ST. TAMMANY PARISH

Addendum No.: 3

Bid#: 23-3-2

Project Name: Cross Gates Water System New Elevated Storage Tanks

CROSS GATES WATER SYSTEM
NEW ELEVATED STORAGE TANK
SLIDELL, LOUISIANA
PROJECT No.: TU22000204
TU22000209
WILLOW WOOD SITE PLAN
(ELEVATED TANK)

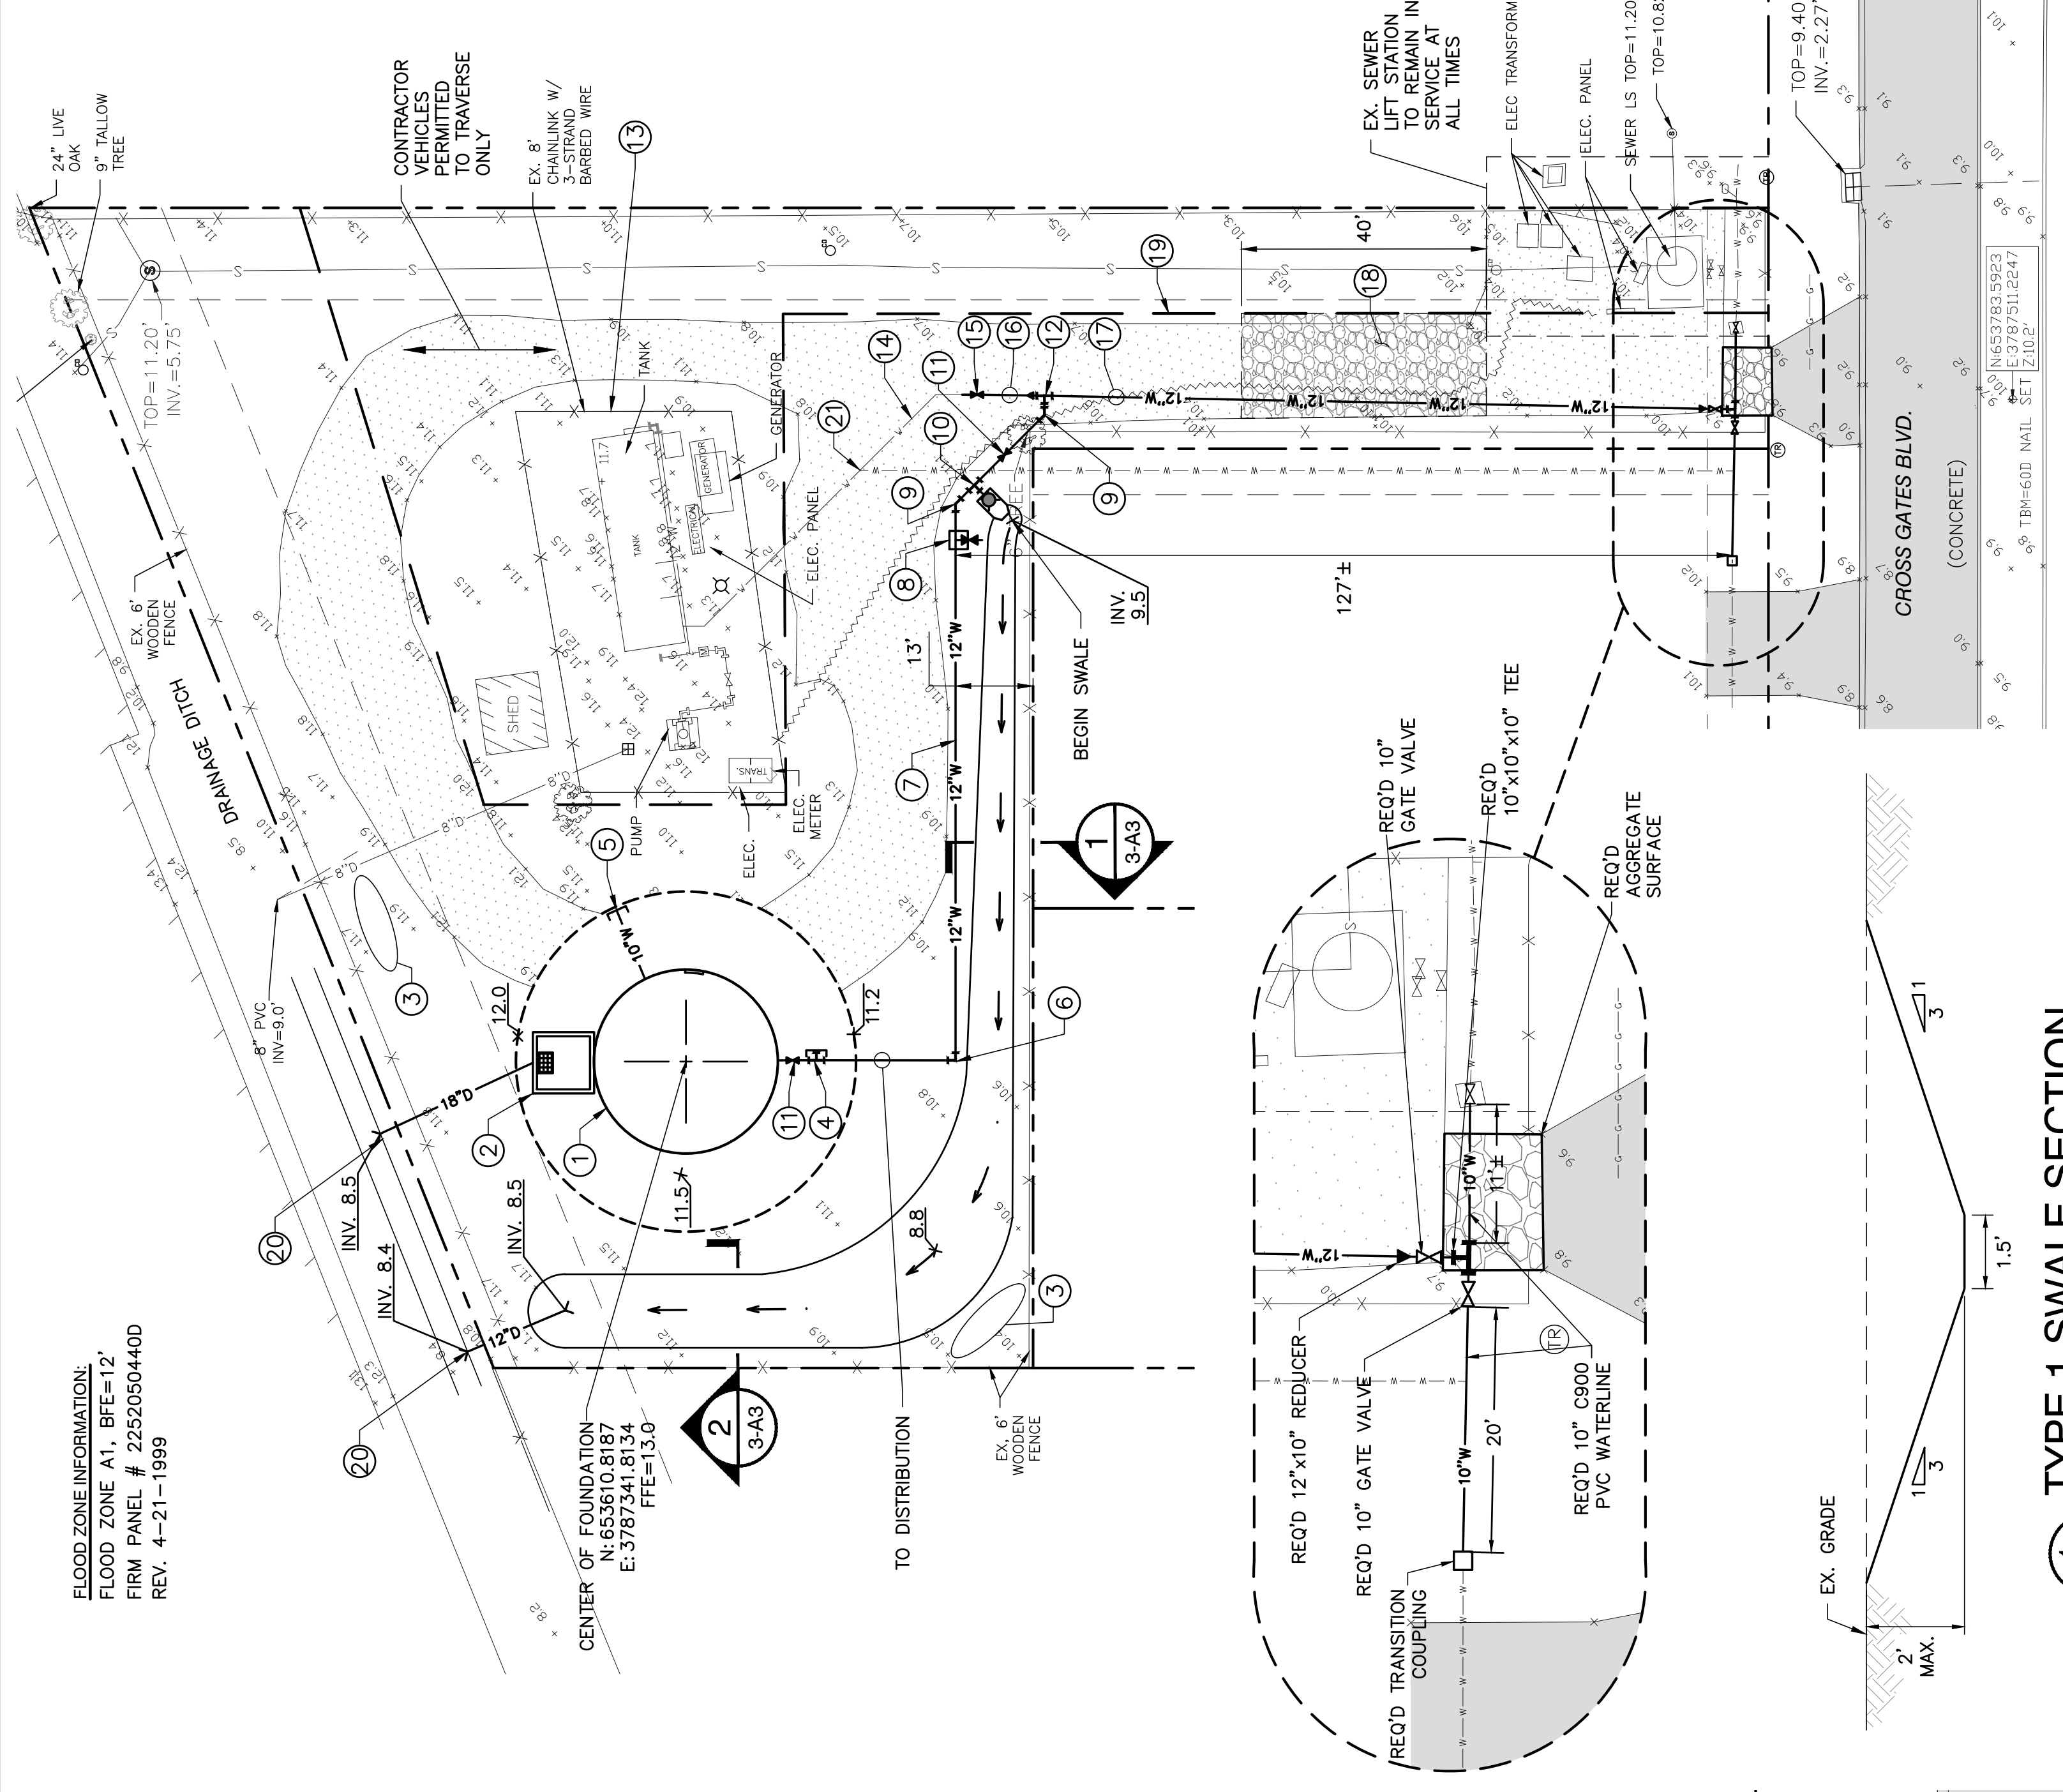
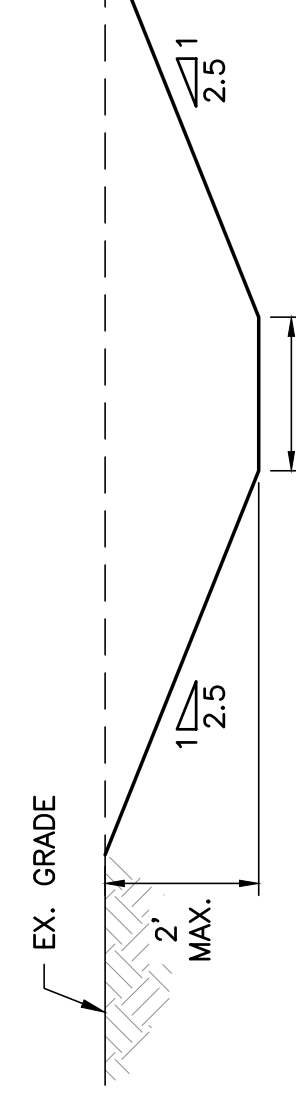
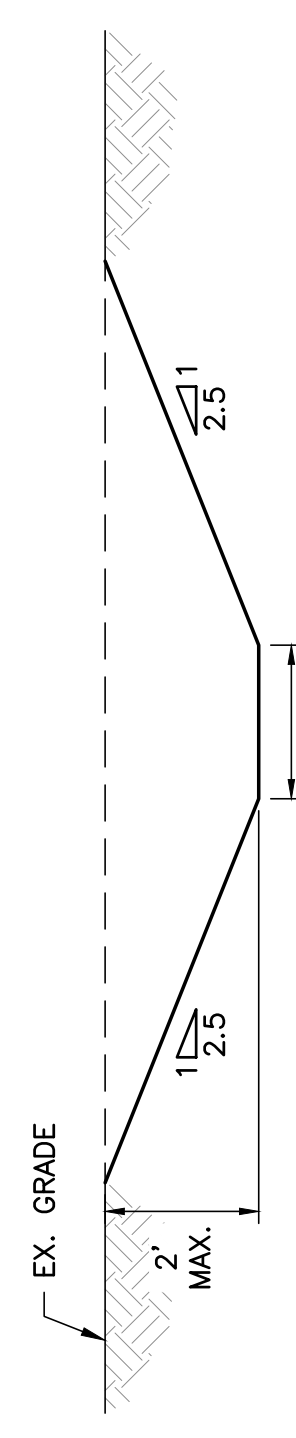
- c. Paragraph 2.4.A.4, **delete** “Optional pH Sensor Flow Cell:PVC” and **replace** with “pH Sensor Flow Cell: PVC”.
5. **Delete** Drawing Sheets 3 and 5, and **replace** with attached Sheets 3-A3 and 5-A3, annotated “Addendum 3” in the revision block.
